**RE: Coors and Central – 100 Coors Blvd NW**  
**Conceptual Grading Plan**  
**Engineer's Stamp Date: No Stamp Date**  
**Hydrology File: K10D017**

Based upon the information provided in your submittal received 12/06/17, the Conceptual Grading Plan **is not** approved for Site Plan for Building Permit. The following comments need to be addressed for approval of the above referenced project:

A1 SECTION A-A  
SCALE: 1"=20'

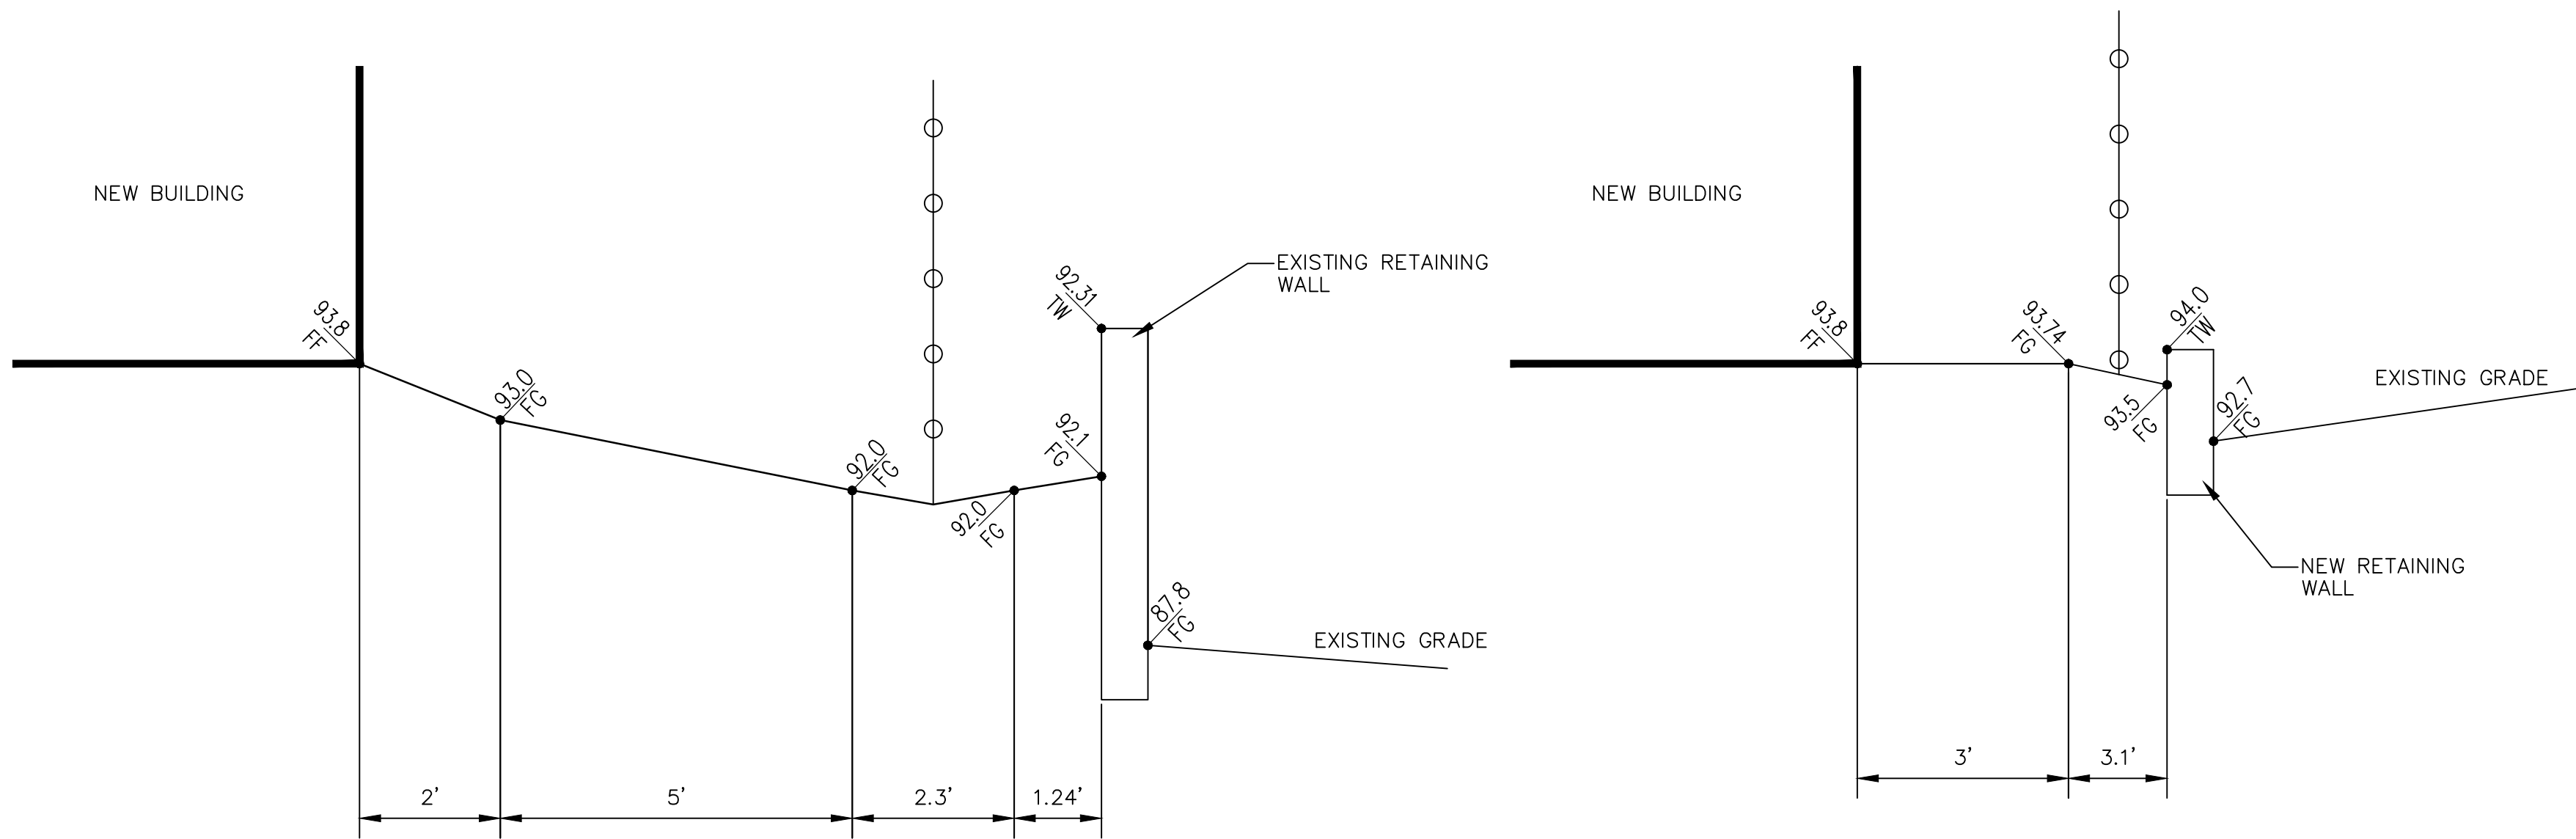
3. Please add the property line in both Section A-A and Section B-B.
4. Please also show the retaining wall footer in both Section A-A and Section B-B.
5. Per DPM Ch. 22.5.B, grading and construction of retaining walls at or near the property line must demonstrate that the adjacent property is not damaged or its use constrained. Any such encroachment by the wall or grading must be accompanied by written permission of both landowners.

A1 CONCEPTUAL GRADING AND DRAINAGE PLAN  
SCALE: 1"=20'

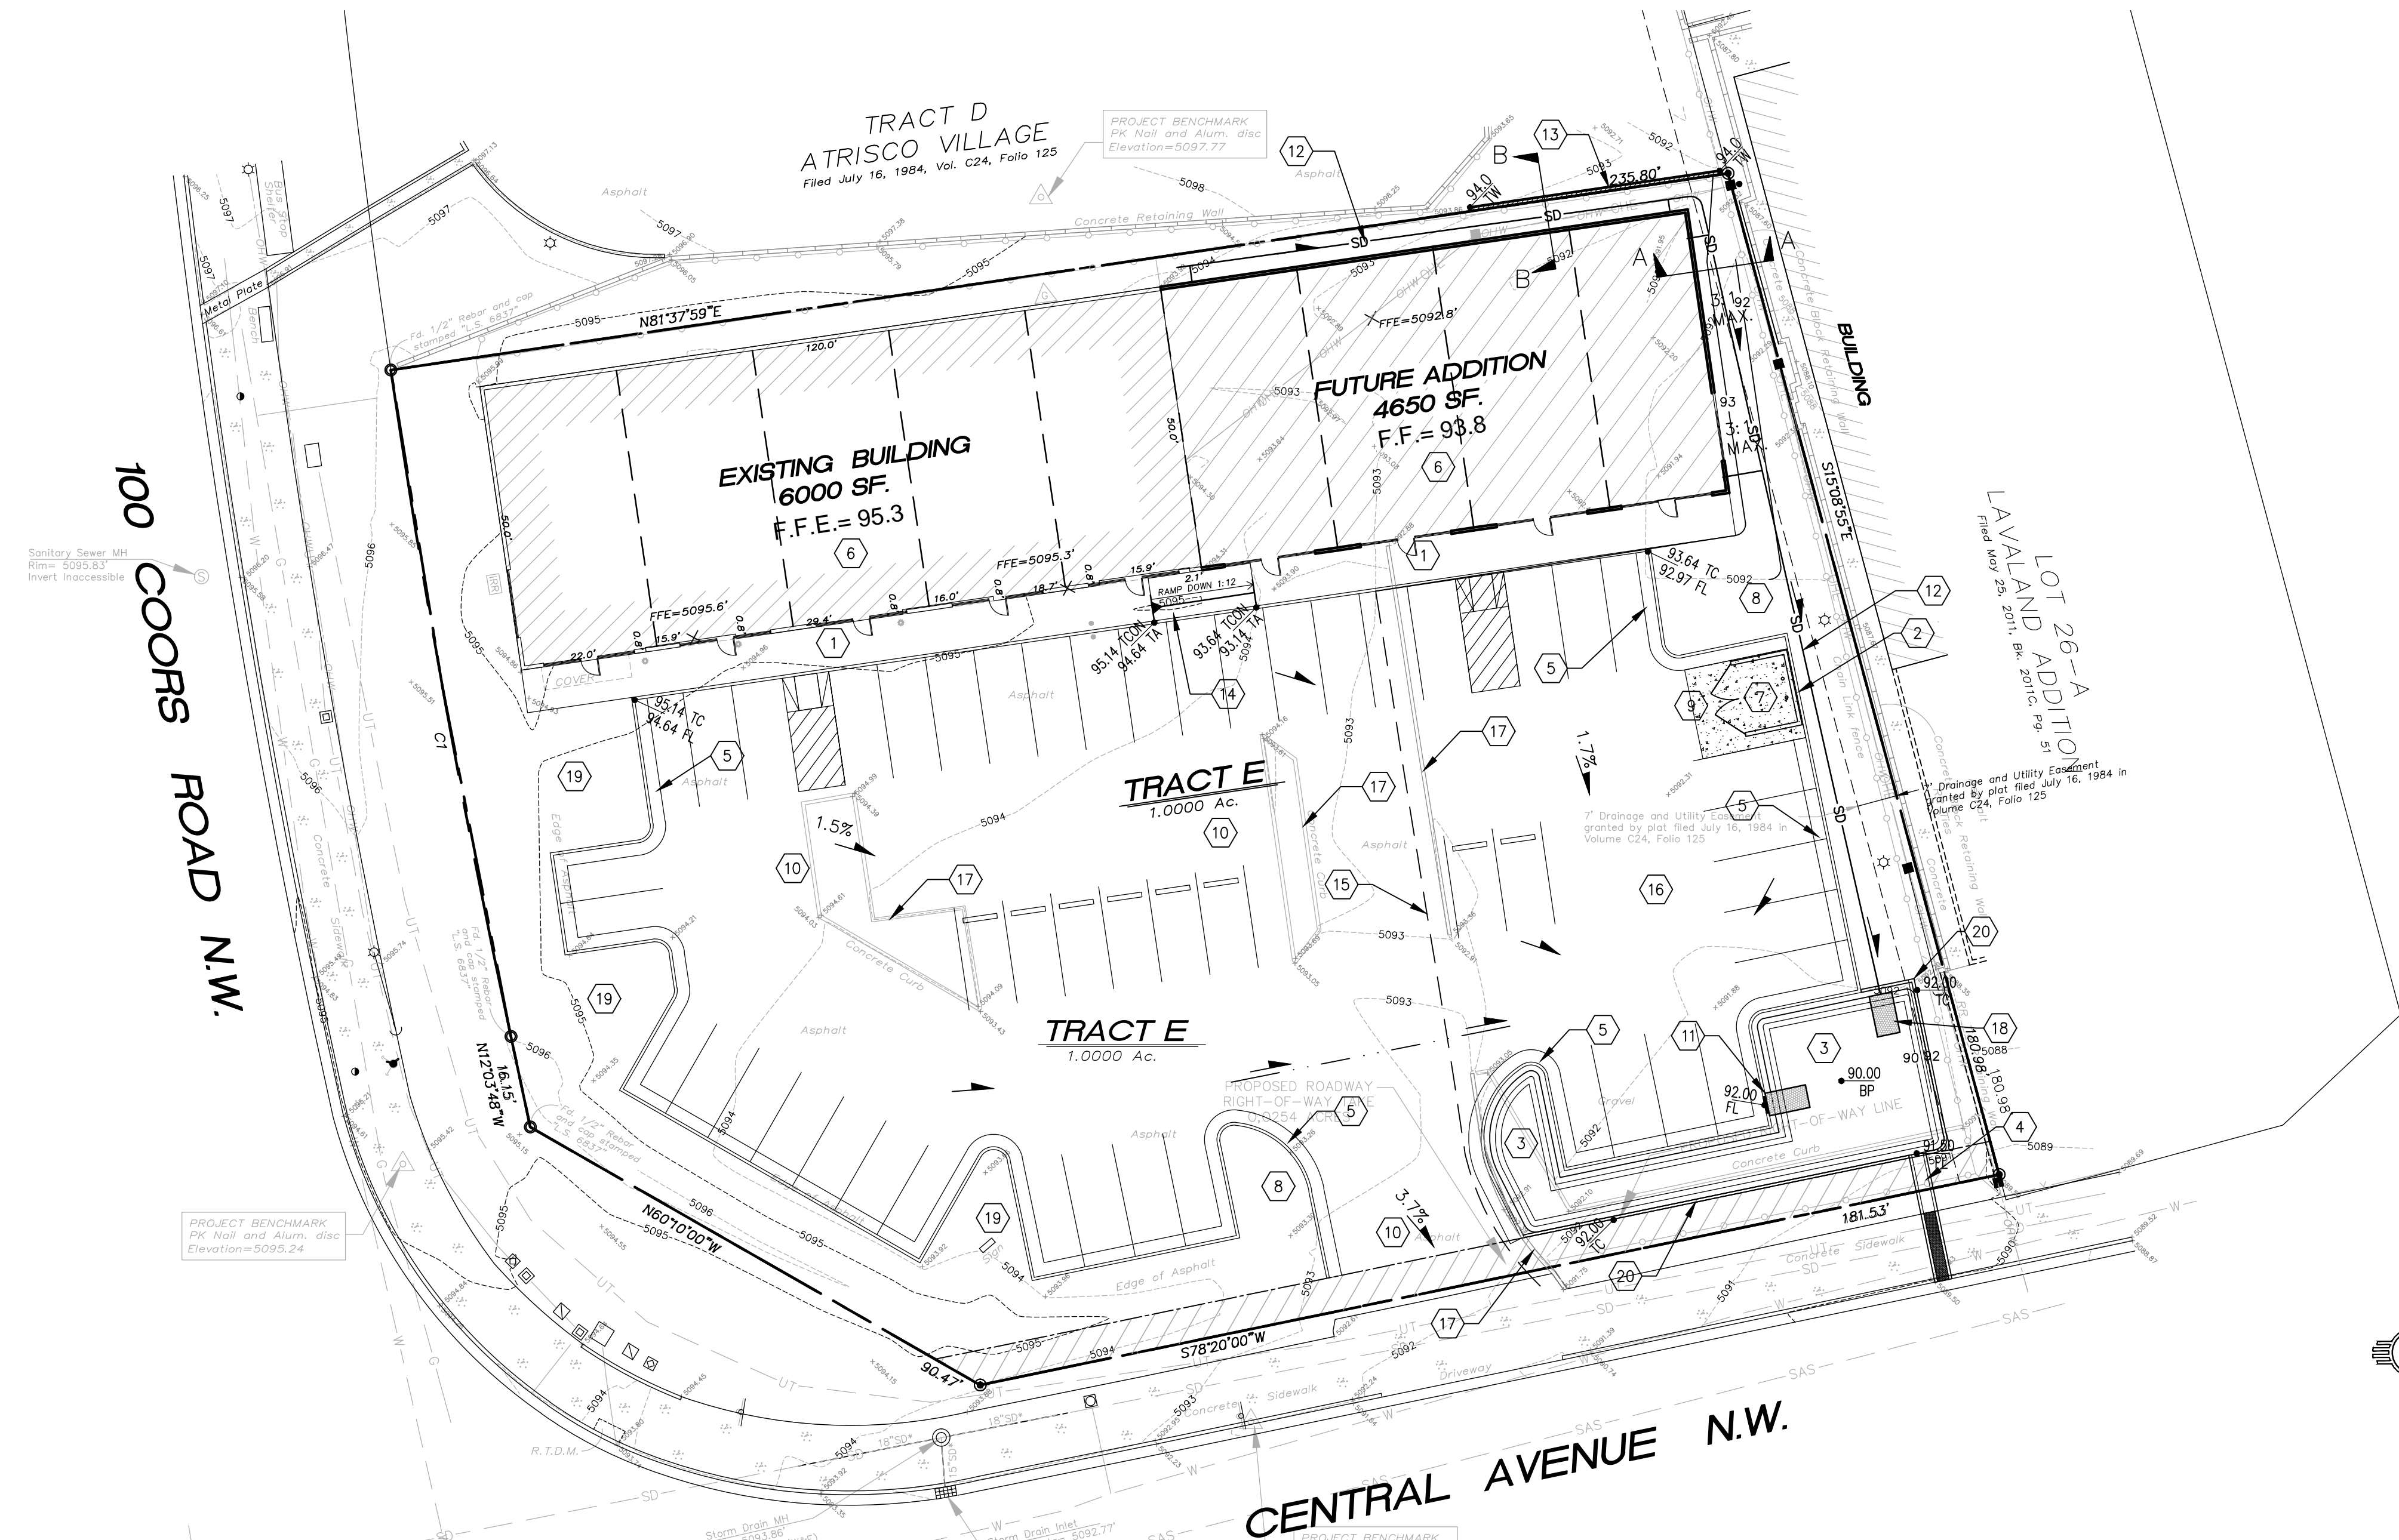
1. Please provide the FIRM Map and flood plain note with effective date.
2. Please provide a vicinity map showing the location of the site. Typically this is the Zone Atlas. This can be downloaded in pdf format from the City of Albuquerque's website.

6. Per Transportation's DRB comments on December 6, 2017, the overall site plan will have some changes and some will affect the drainage. Please insure that the Conceptual Grading Plan matches the Site Plan for Building Permit.
